APPENDIX D – MODEL DOCUMENTATION REPORT

**Modeling Documentation
Report: S190 Operations
Study**

**US Army Corps
of Engineers** ®
Jacksonville District

Figure 2. PC17A structure schematic.

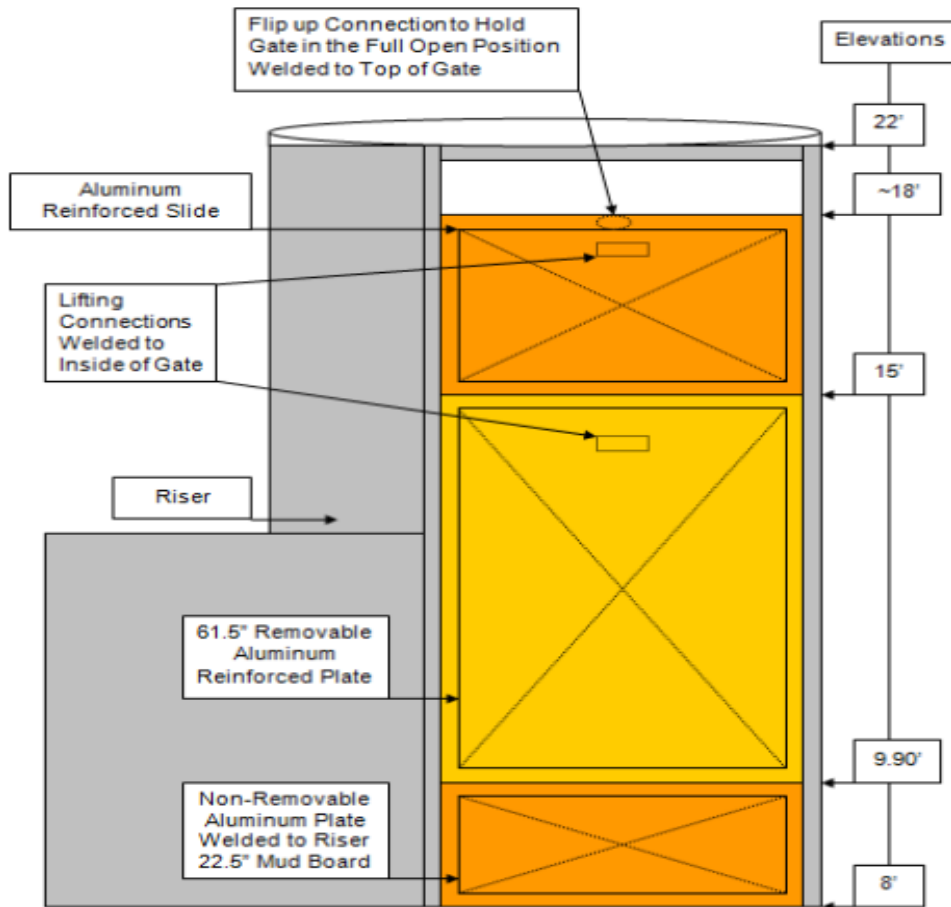
39	STOF(4): Pg.7, Fig. 2... 4a. 4b. 4c. 4d. 4e.	Seminole Tribe	STOF	STOF	Underlined and added text in red noted; a. b. yes c. water quality should be considered separately from the hydraulic and hydrologic analysis provided in this MDR. This will be addressed in the EA.	7	NC	Done
40	STOF(5): Pg. 7, last paragraph, 4th sentence... 5a. 5b. 5c.	Seminole Tribe	STOF	STOF	Noted. MDR revised to differentiate between the "Existing" vs. "design" operating criteria. Noted. MDR will be revised.	7	NC	Done
41	STOF(6): Pg. 7, last paragraph	Seminole Tribe	STOF	STOF	Noted. Charts provided in Fig 6-8 shows dry season's stages held at 15.2-15.8 for most of the wet season. Language will be revised to include "most for the wet season".	7	NC	Done
42	STOF(7): Pg. 8, 1st paragraph, 1st sentence	Seminole Tribe	STOF	STOF	Noted. Typo corrected in MDR.	8	NC	Done
43	STOF(8): Pg. 8, 2nd para, last sentence	Seminole Tribe	STOF	STOF	Sentence rephrased to remove speculation about operation of PC-17A Noted. Typo corrected.	8	NC	Done
